DATE: July 25, 2025
TO: ALL CONTRACTORS
FROM: ROBBIE STROM
PROJECT: ALOE BAY HARBOR TOWN PHASE II – PACKAGE I DESOTO AVENUE BOARDWALK & BULKHEAD #M1A101-ABHT FOR THE TOWN OF DAUPHIN ISLAND GMC PROJECT NO. CMOB220084(1)
RE: ADDENDUM #1

ADDENDUM NUMBER 1

ALOE BAY HARBOR TOWN PHASE II – PACKAGE I DESOTO AVENUE BOARDWALK & BULKHEAD #M1A01-ABHT
FOR
TOWN OF DAUPHIN ISLAND
GMC PROJECT NO. CMOB220084(1)

2. Revisions to Plans

G2 sheet of

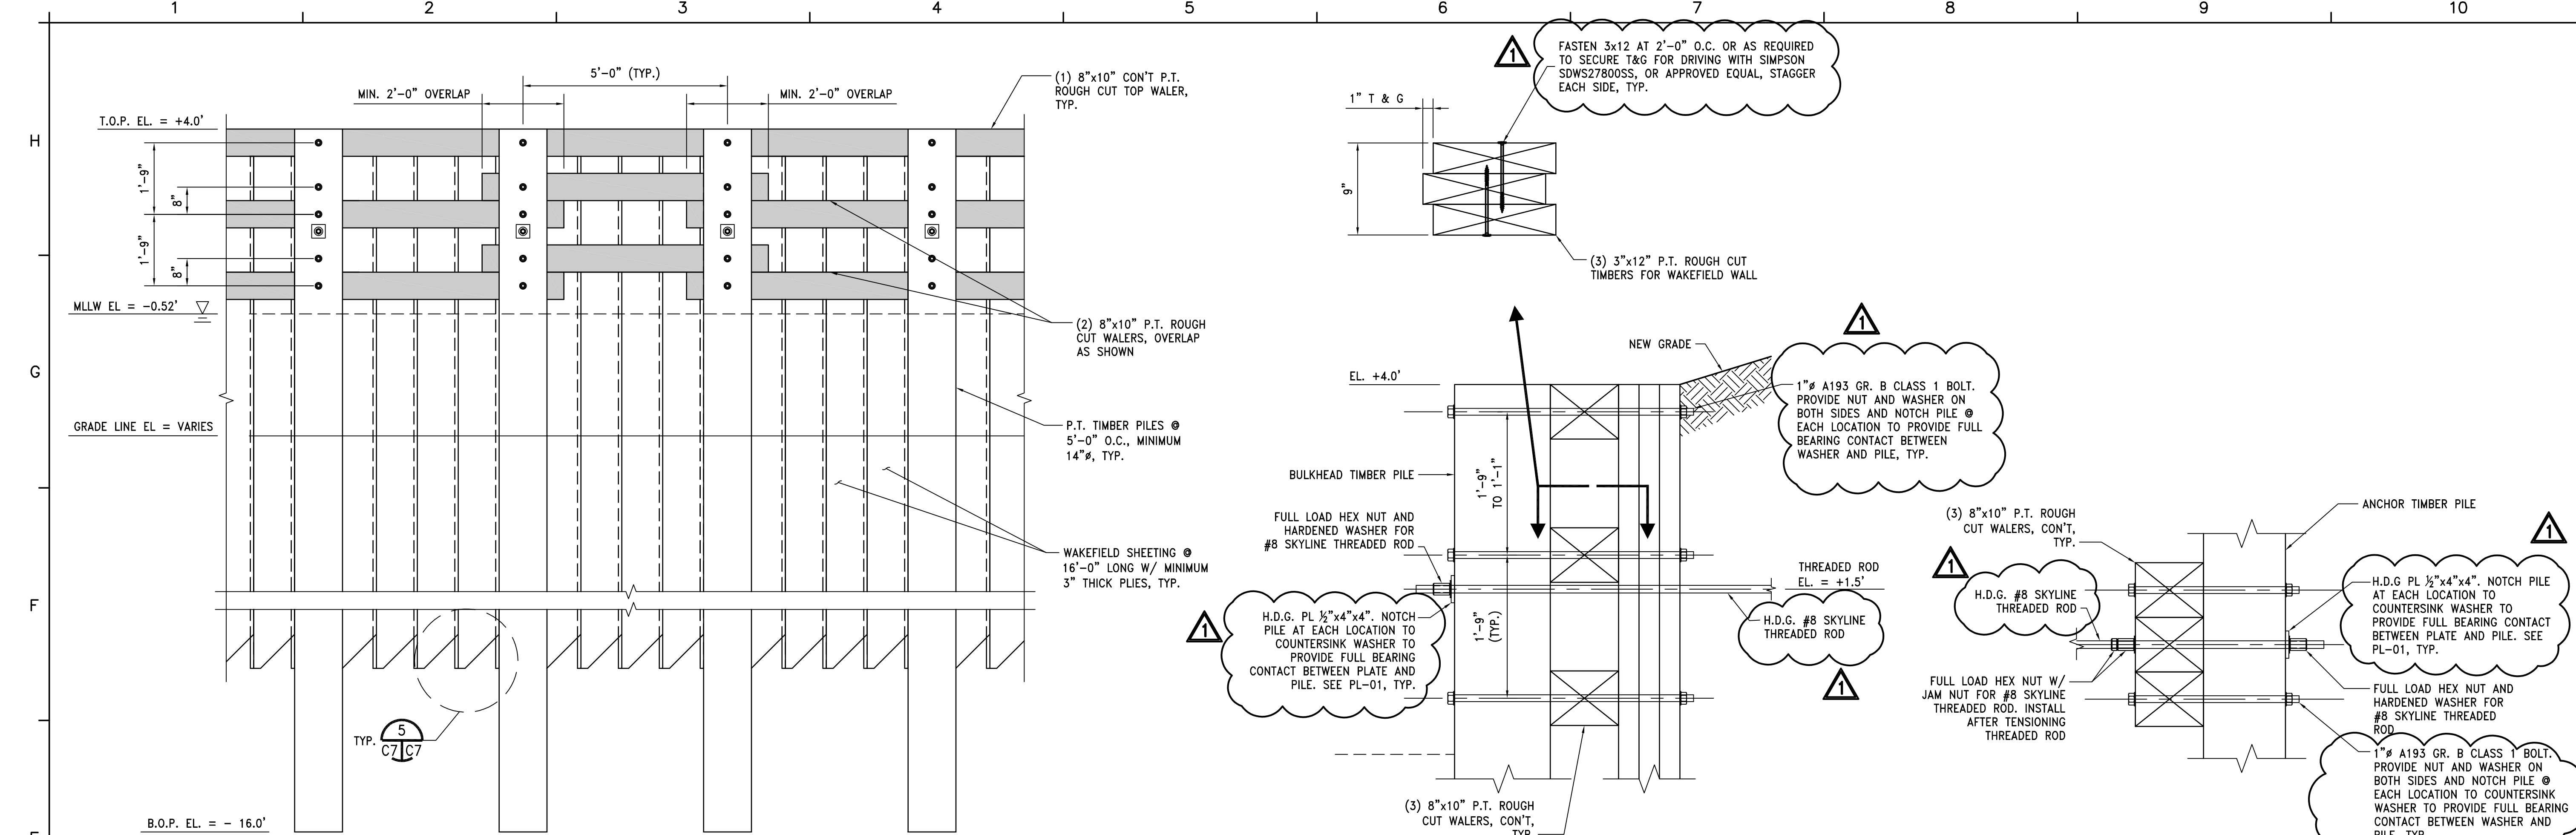
- 4.2 **Are pile templates a requirement for the timber pile operations as stated on G2 #2 under wood piling?** Not required but a good idea. Piles shall be in correction location.

- 4.3 **Will vibratory driving be allowed for timber pile and wakefield sheeting? If so it will not be possible to provide the information on #6 - #9 under wood piling on G2.** Vibratory Hammer is acceptable.

C7
sheet of

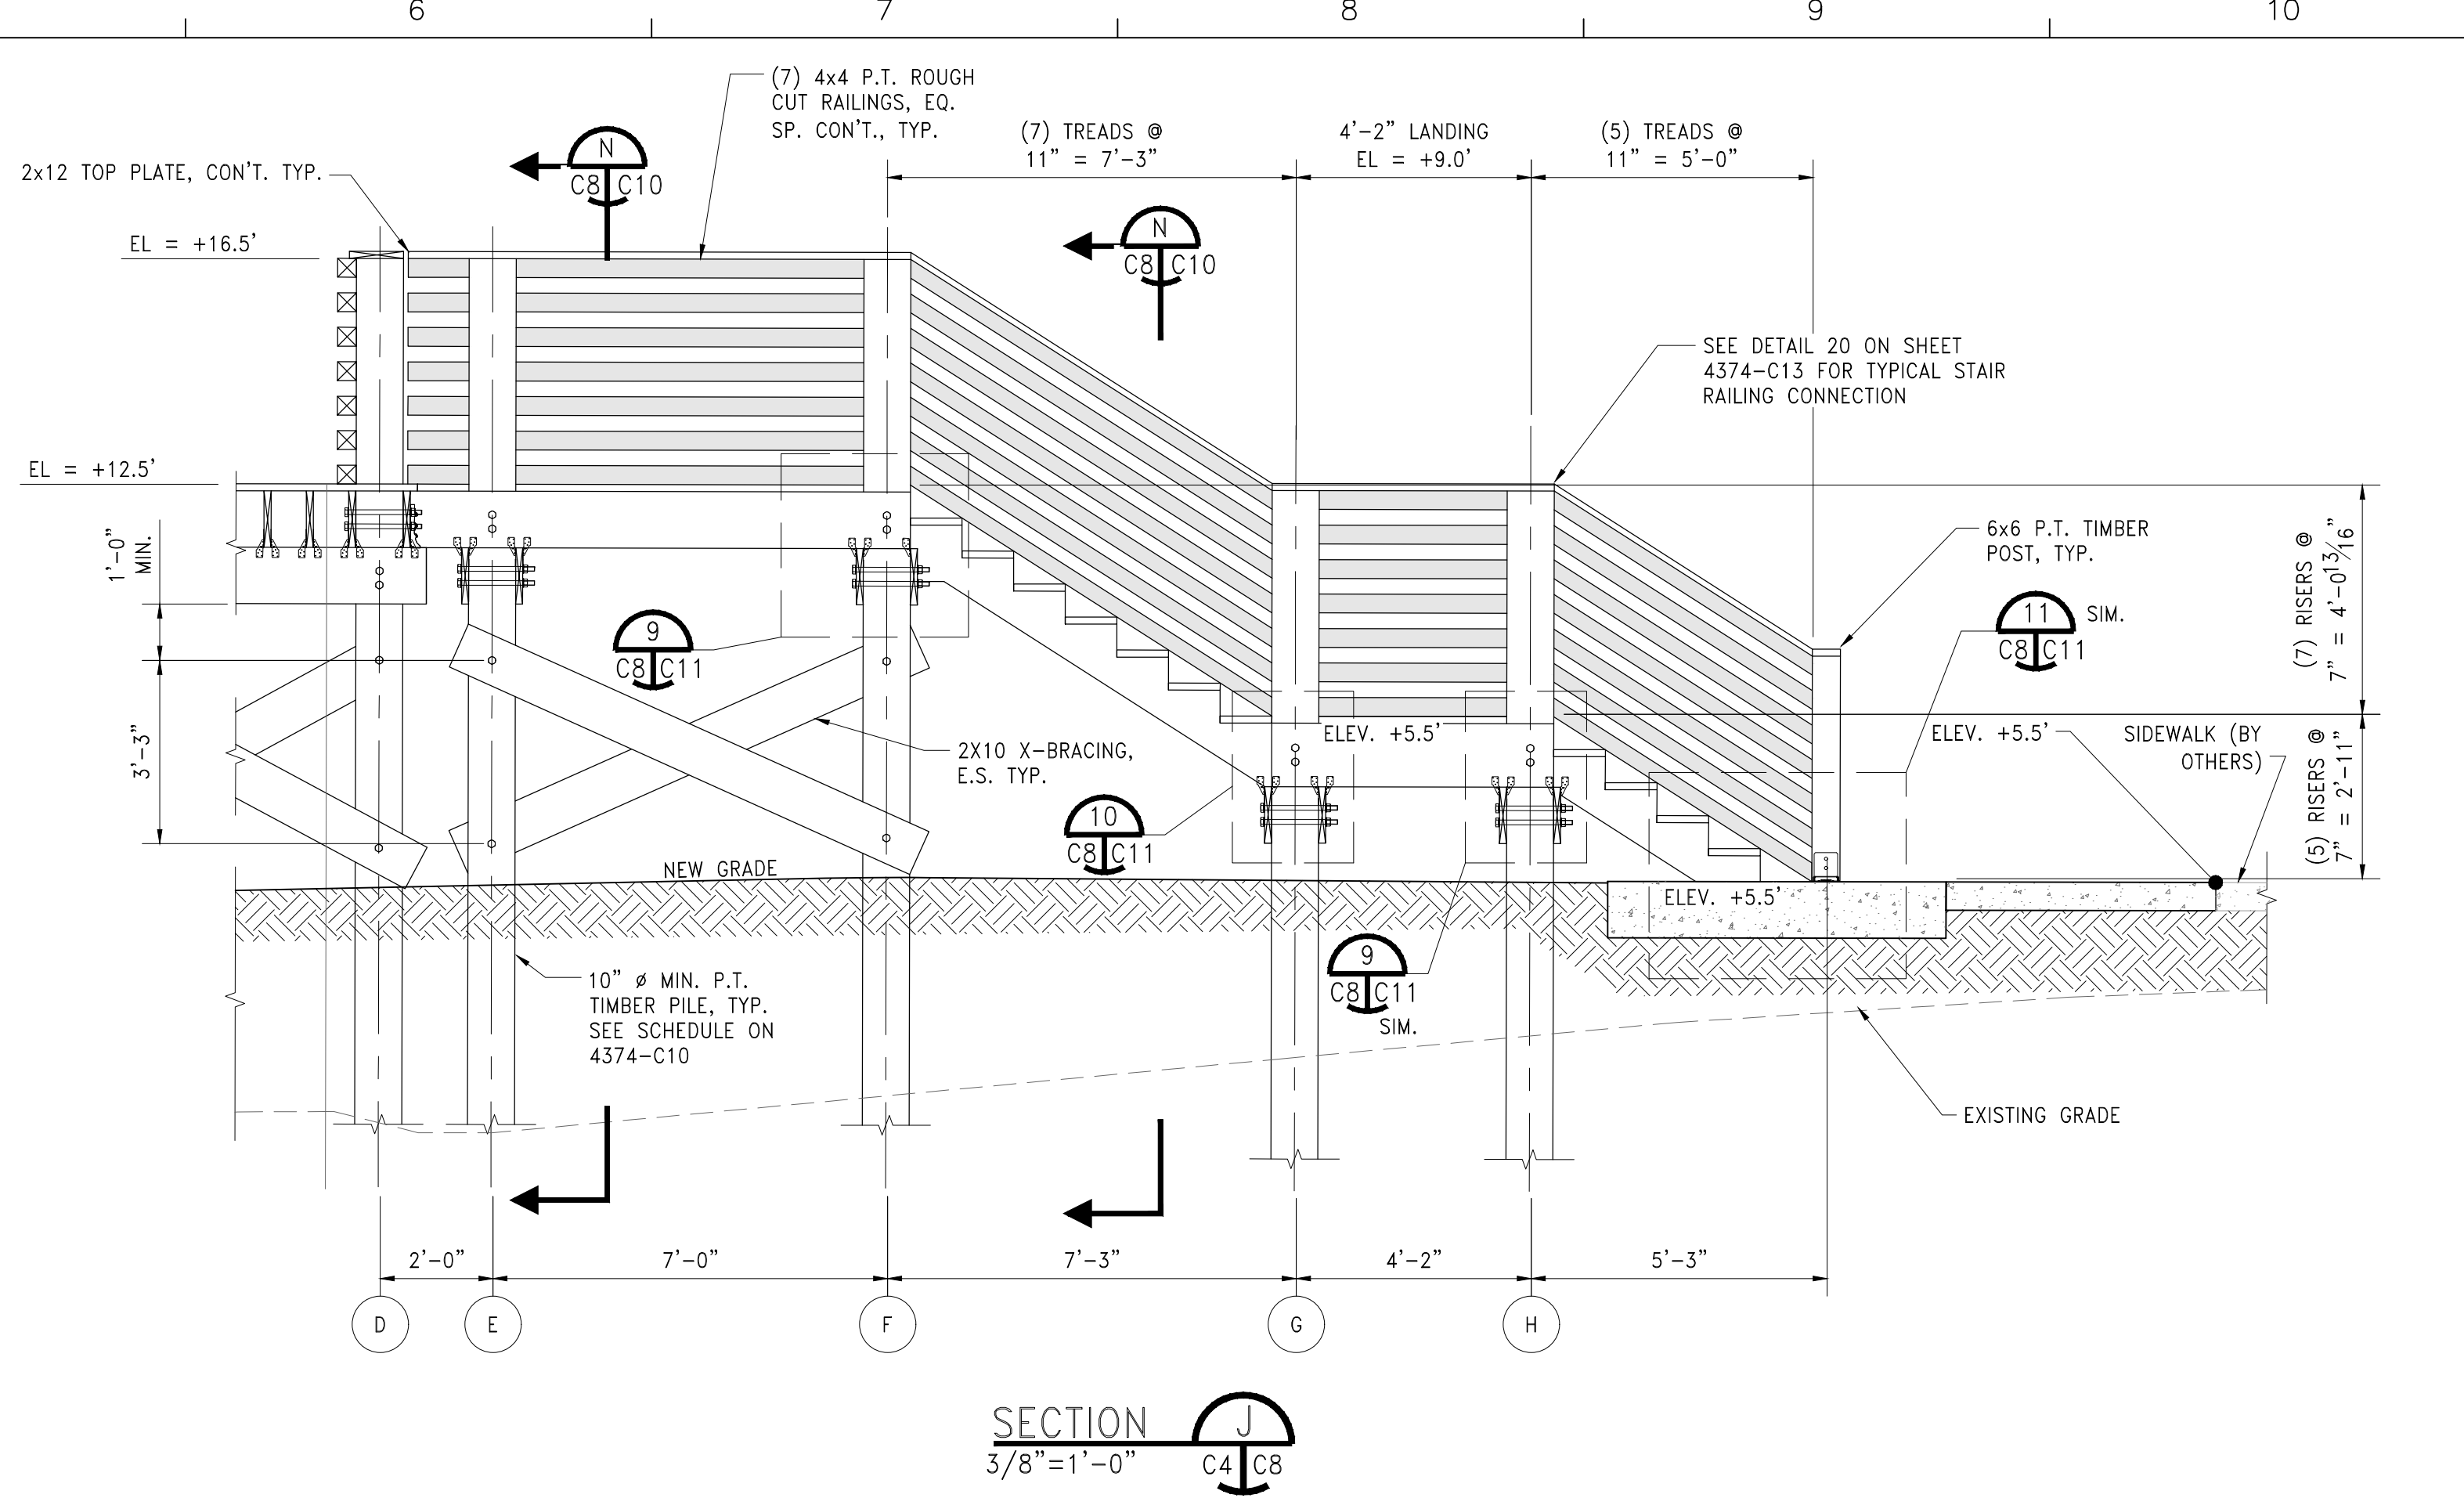
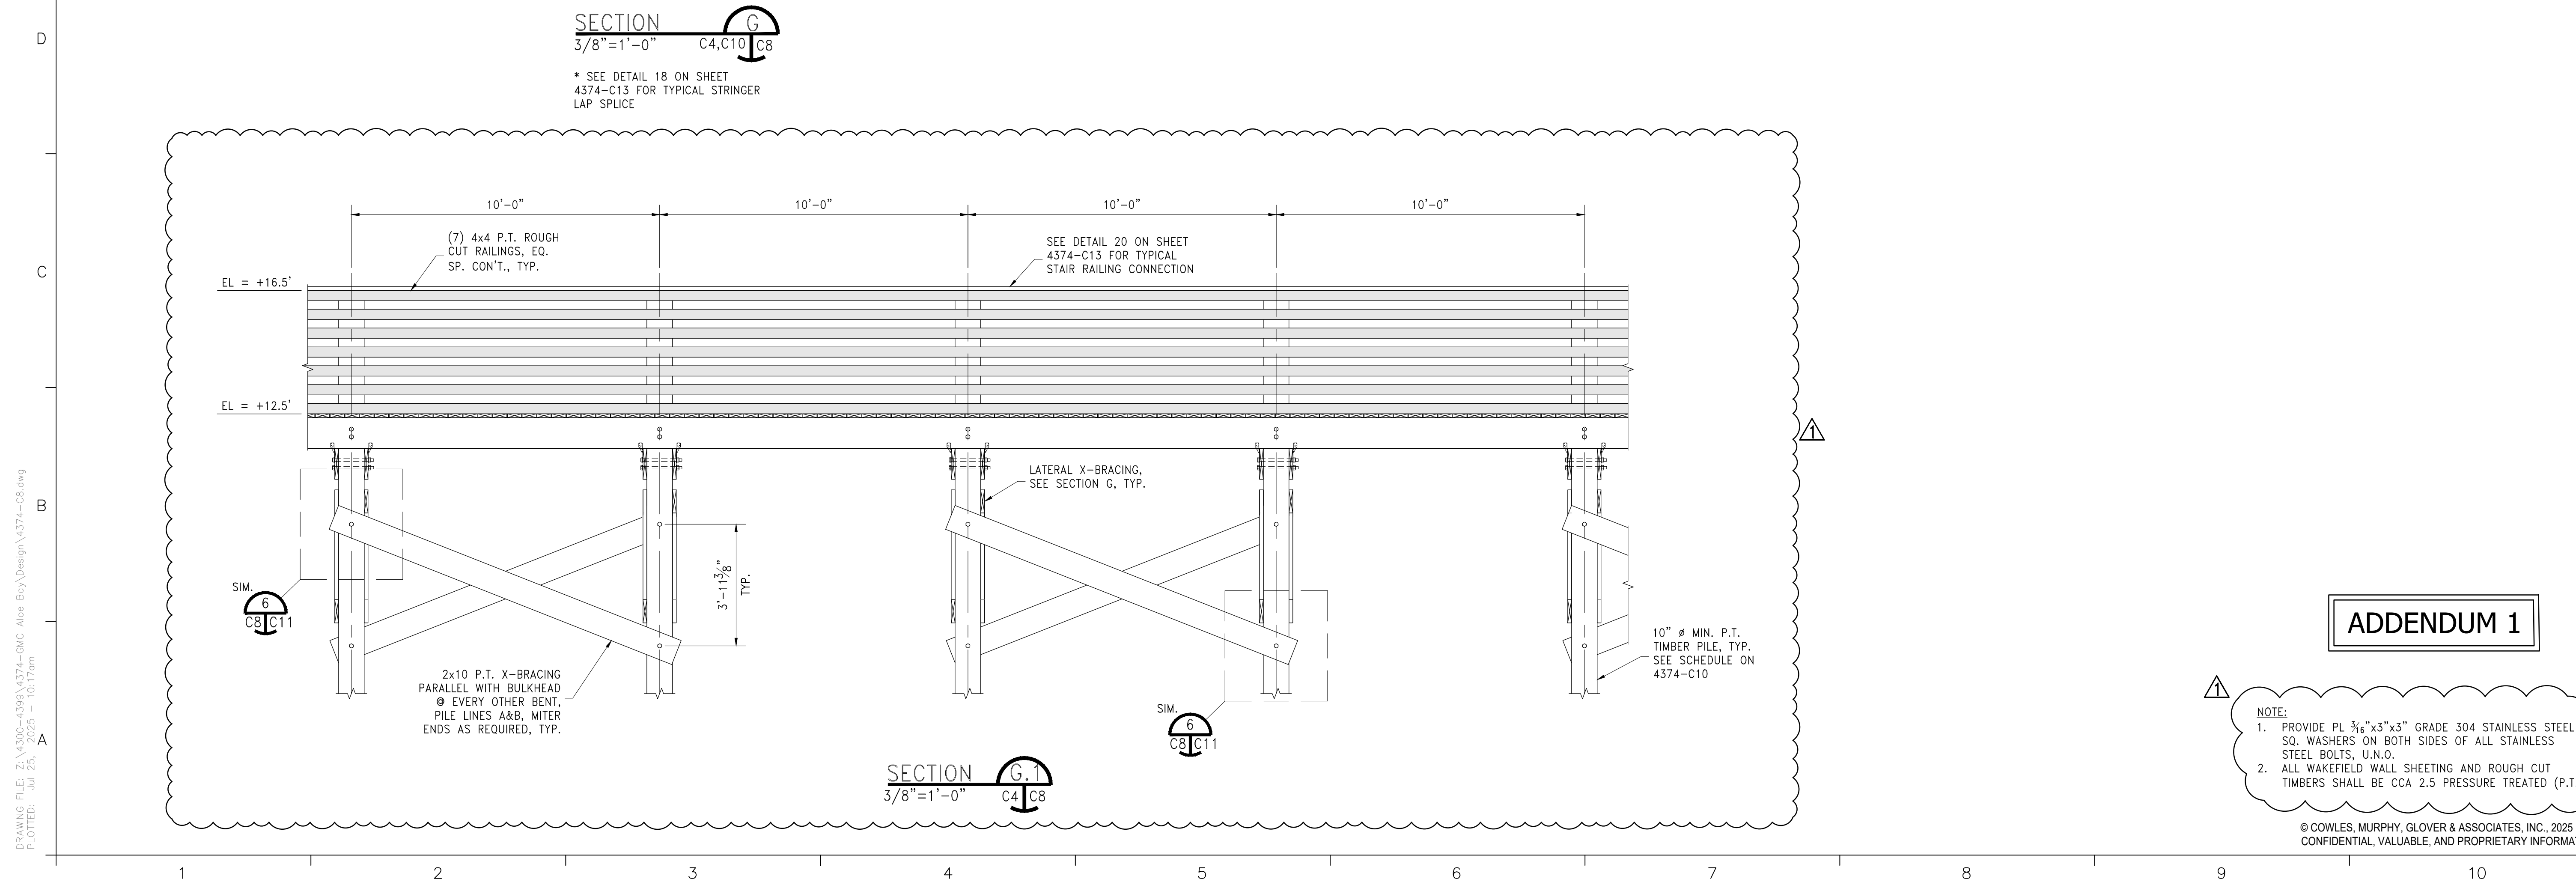
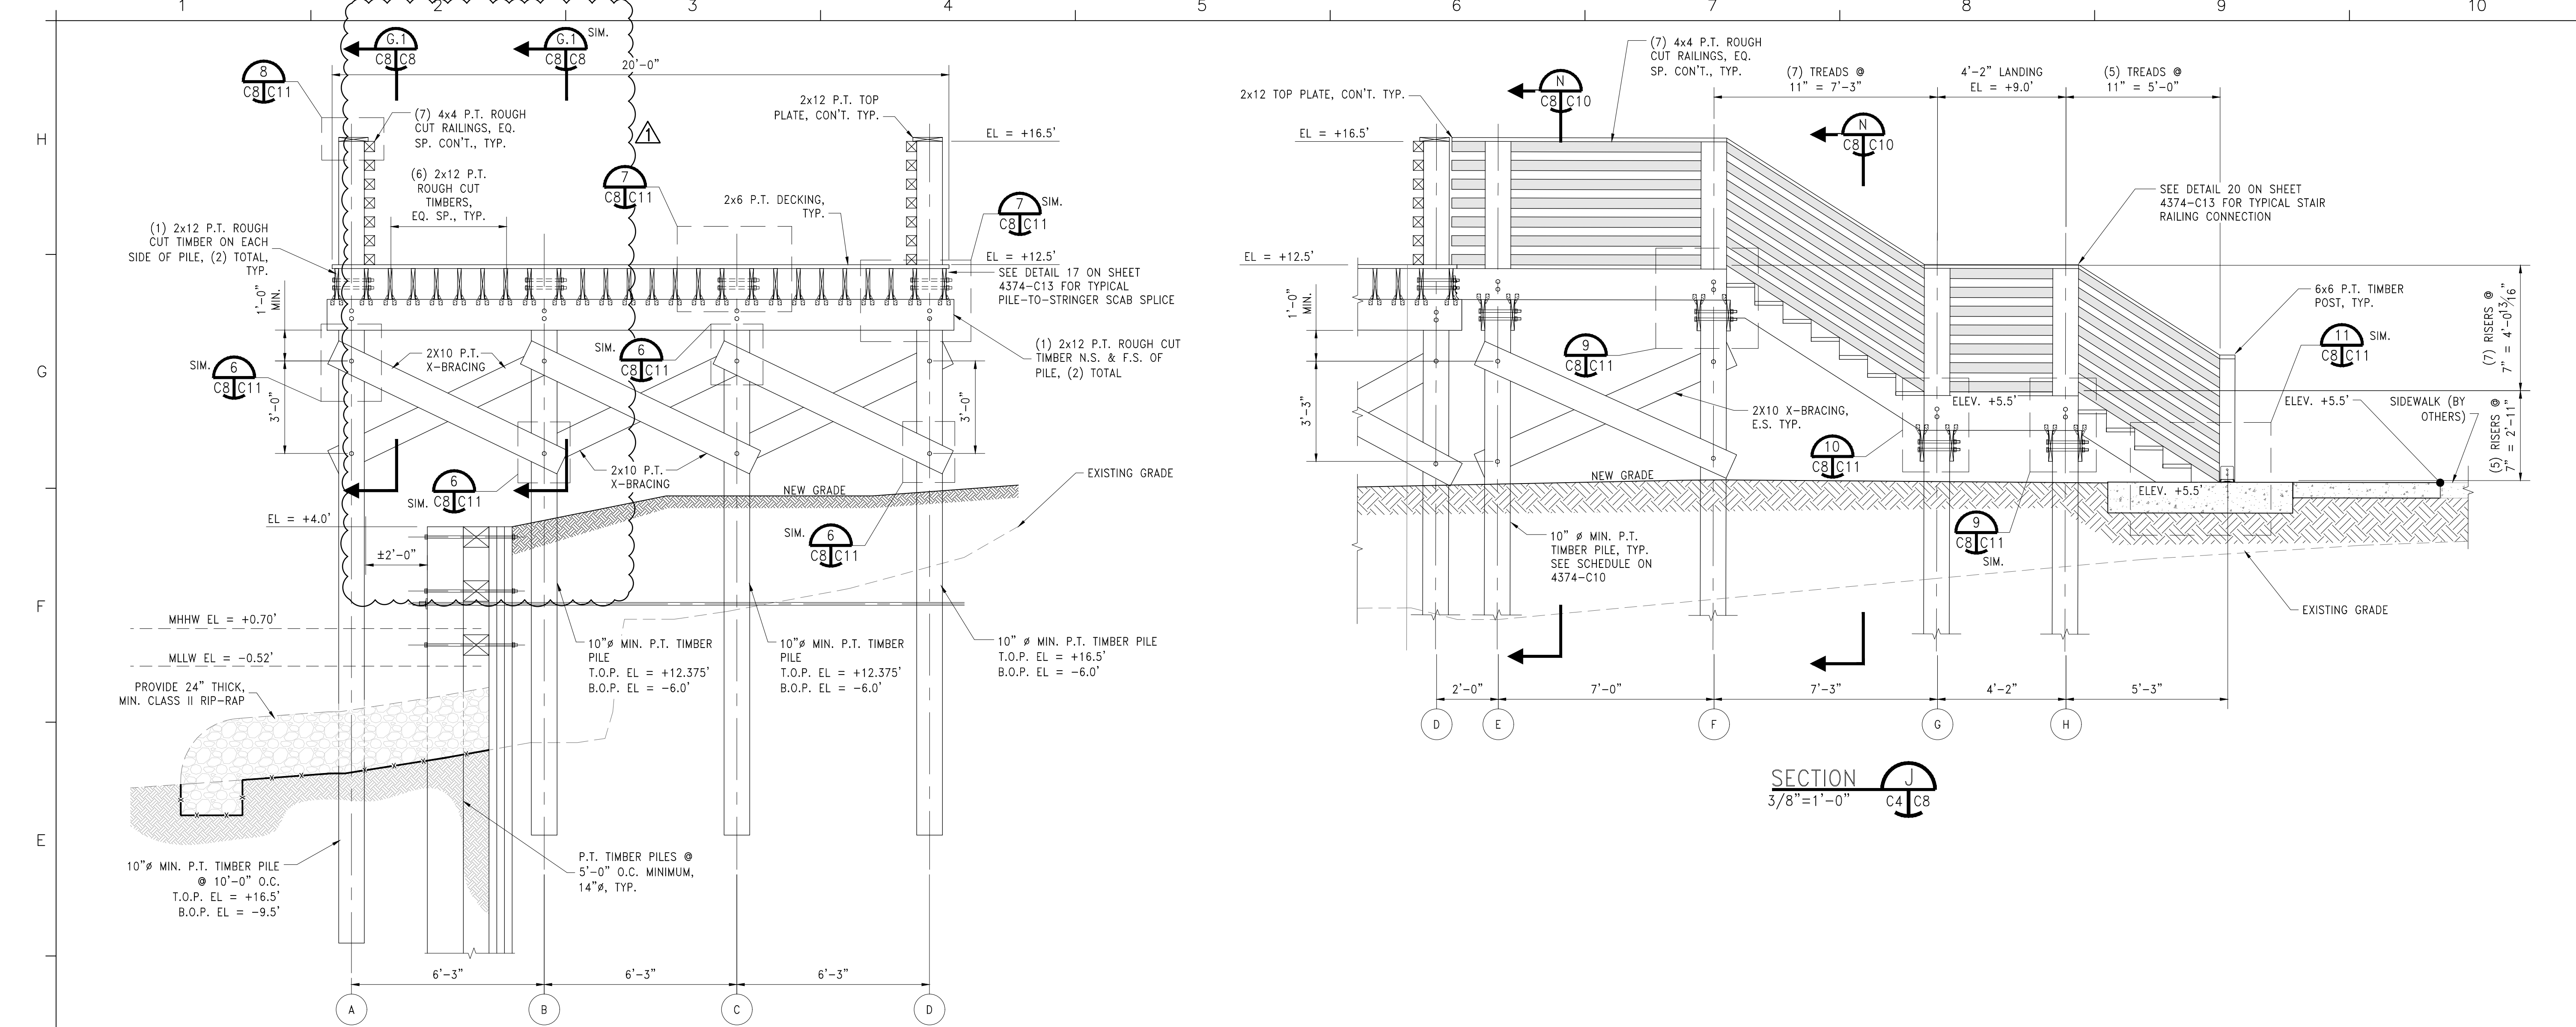
- 4.12 **What is the size of the rod securing the Whalers? I see the #8 rod for the dead men but not the whaler rod.** See 4374-C7 Addendum 1, Details 1 and 2: Use 1" dia. A193 Grade B Class 1 bolts.
